v12 change log:

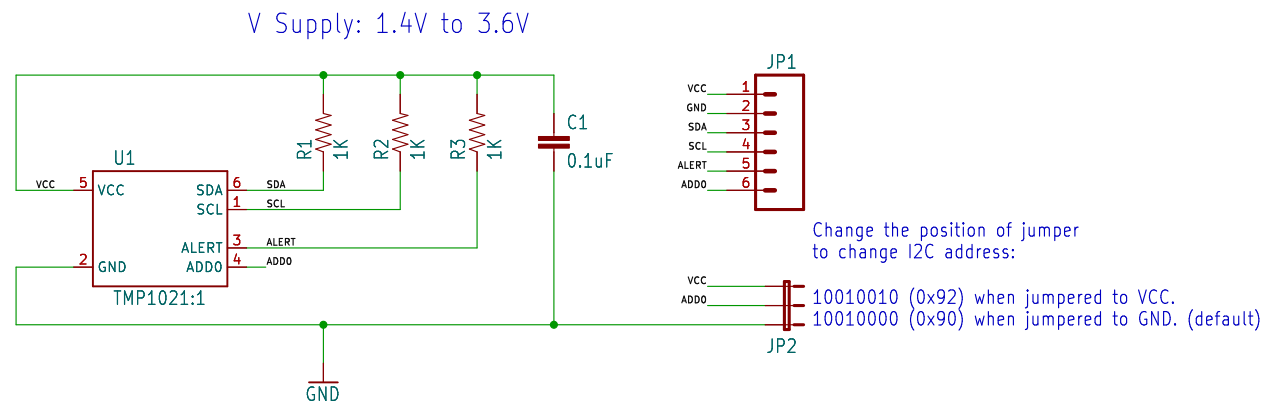
- 1) 0402 to 0603 resistor footprint
- 2) 1:1 main IC footprint
- 3) Re-route traces directly away from IC
- 4) Ver # in bottom copper
- 5.) Added jumper for ADD0 select (default gnd)
- 6.) Added mounting holes
- 7.) Moved all headers to same side
